**Draft Disability (Access to Premises – Buildings)
Standard**

**SUBMISSION TO THE
FEDERAL PARLIAMENT'S LEGAL AND CONSTITUTIONAL
AFFAIRS COMMITTEE**

By Mark Relf

13th March 2009

Platform area:

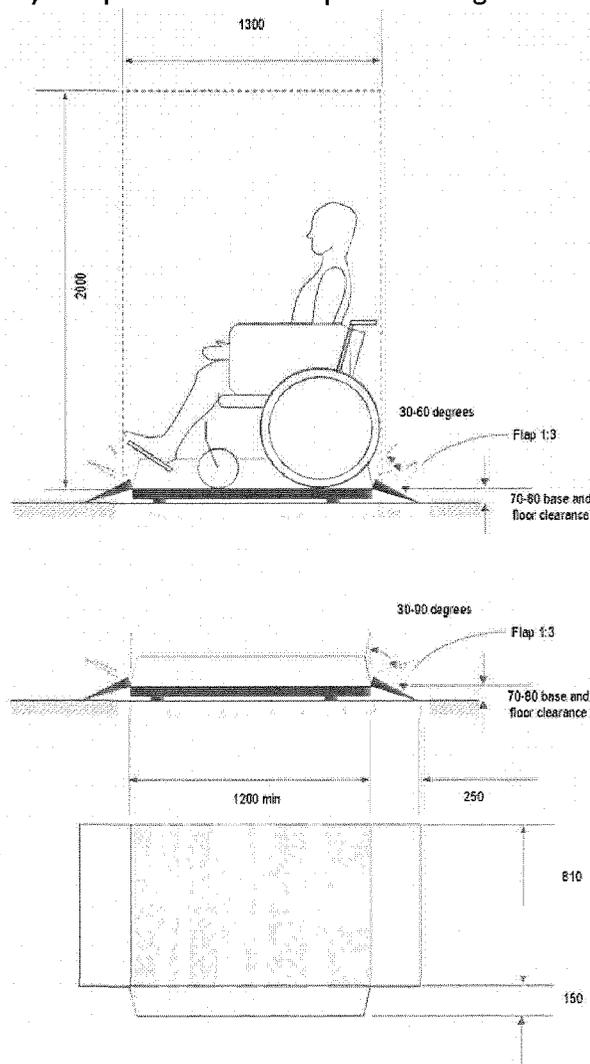
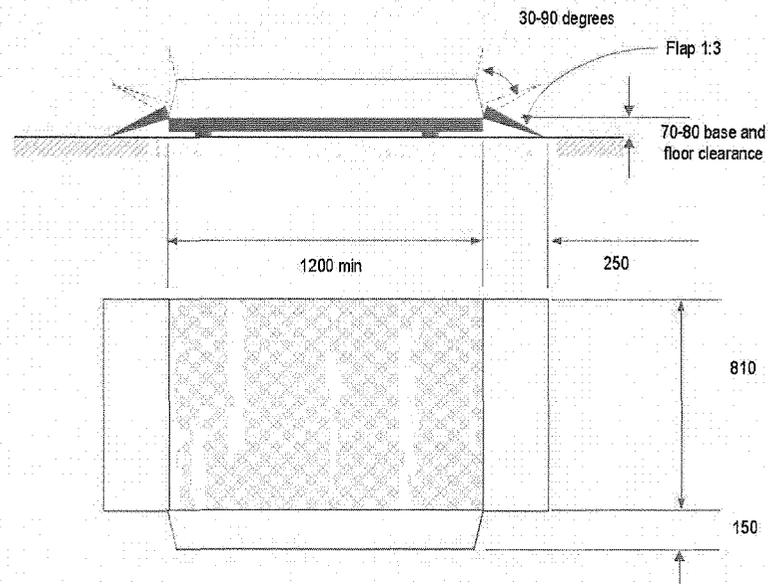
Table I requires the minimum platform dimensions to be 685mm wide x 1000mm long. However the draft DDA Premises Standard requires the minimum platform size for stairway lifts in public buildings to be 810mm wide x 1200mm long. It is recommended therefore that Table I be amended to show the platform minimum dimensions as 1200mm long and 810mm wide. The Note to Table I states that length is measured horizontally in the direction of travel between the safety flaps in the elevated position or the sensitive edges in the non-actuated position, whichever applies. The position at which length is measured is not clear to all readers and it is recommended that a Figure be provided to clarify the requirement.

- It is recommended therefore that Table I be amended to show the platform minimum dimensions as 1200mm long and 810mm wide.
- It is recommended that a Figure be provided in association with Table I to clarify the position at which platform length is measured.

End Person Clearance:

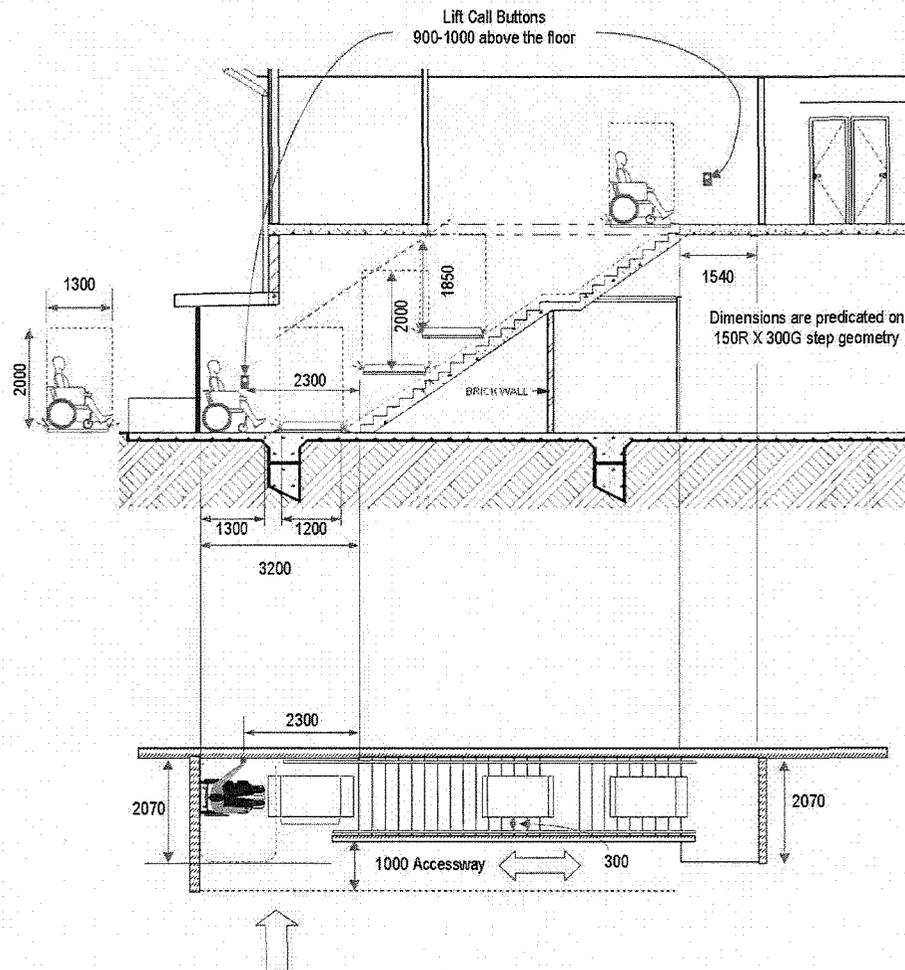
While Clause 14 refers to an end person clearance of 300mm, this clearance does not address the necessary wheelchair circulation space as shown in the figure below required for the bottom landing and the top landing. Access to the platform shall be by end approach only.

- It is recommended that a sub-Clause be added to Clause 14 requiring wheelchair circulation space as shown in the figure below at the bottom landing and at the top landing for stairway lifts in public buildings.
- It is recommended that a sub-Clause be added to Clause 14 requiring access to the platform to be by end approach only for stairway lifts in public buildings as shown in the figure below.
